RC2: 'Comment on amt-2021-84', Anonymous Referee #2, 18 May 2021

This paper presents progress towards implementing an aerosol retrieval to the existing CLARS-GFIT algorithm. The CLARS-FTS instrument is a peculiar ground-based FTS as it collects solar spectra from reflected sunlight rather than observing the sun directly. Because of the much lower signal with reflected sunlight, the effect of aerosols must be included in the forward model. The paper presents experiments with the new algorithm to estimate the effect on retrieved GHGs of simultaneously retrieving the aerosol optical depth and aerosol layer height.

Figure. Comparison of observing geometries of CLARS, TCCON, and satellites.

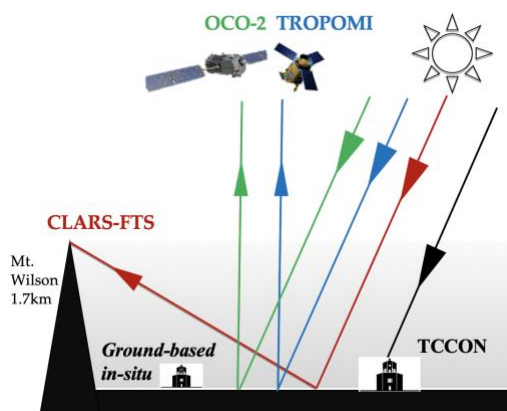
Is CLARS-FTS able to target the Pasadena TCCON site located at CalTech? Can it be used to validate its GHG retrievals? This could be discussed in the text.

Unfortunately, due to mountain ridges in the line of sight, CLARS-FTS cannot directly target the TCCON site at Caltech. On the other hand, TCCON uses directly transmitted solar spectra to measure GHG columns, which have different observing geometries from CLARS observations, as shown in the figure below (red for CLARS and black for TCCON). Therefore, a direct comparison is not feasible. The interpretation of the comparison would need to consider the spatial heterogeneity of GHG distributions between the incident and reflected solar paths in the boundary layer. Therefore, to make such a comparison, we would need to reconcile the difference in observing geometries, which is beyond the scope of this study.

We added the following sentences in the revised manuscript:

“Unfortunately, direct comparison of XGHGs with existing TCCON data at Caltech is not feasible. On one hand, CLARS-FTS cannot directly target the TCCON site at Caltech due to mountain ridges that block the line of sight. On the other, TCCON uses directly transmitted solar spectra to measure GHG columns, which have different observing geometries from CLARS observations; the spatial heterogeneity of GHG distributions between the incident and reflected solar paths in the boundary layer make the results difficult to compare.”
